Re: Turkey Point Unit 3
Docket No. 50-250
Response to Request for Additional Information Regarding the
2007 Steam Generator Tube Inspection (TAC NO. MD9234)

**Response to NRC Request for Additional Information
2007 Steam Generator Tube Inspections
Turkey Point Nuclear Power Station, Unit 3
Docket Number 50-250**

PHOTO 1 - SG 3A
FLEX GASKET MATERIAL REMOVED

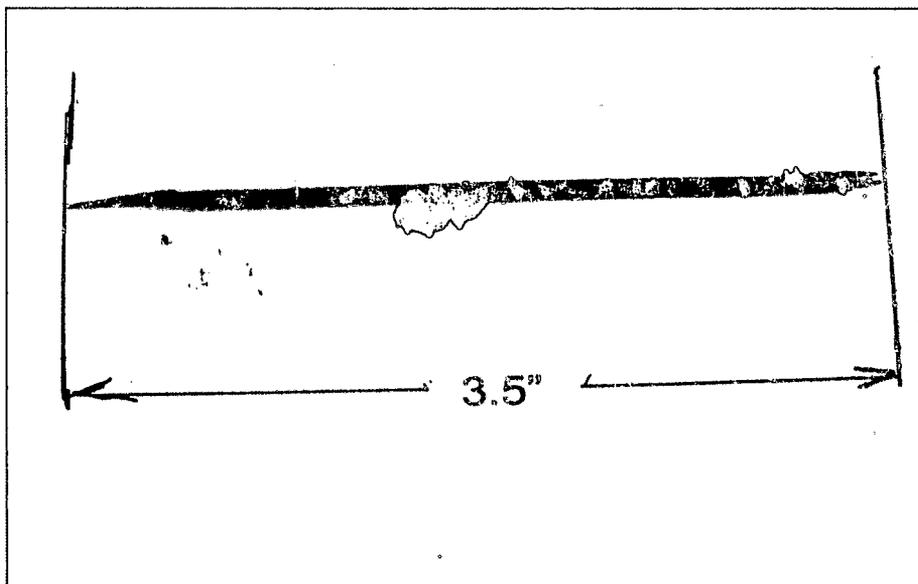
In addition to known objects from the prior outage, seven new objects were identified. Four of these objects were removed from the steam generators and are shown in the photos below. All objects remaining, or presumed to remain in the steam generators, are evaluated for adverse impact on steam generator operation and tracked during future inspections.
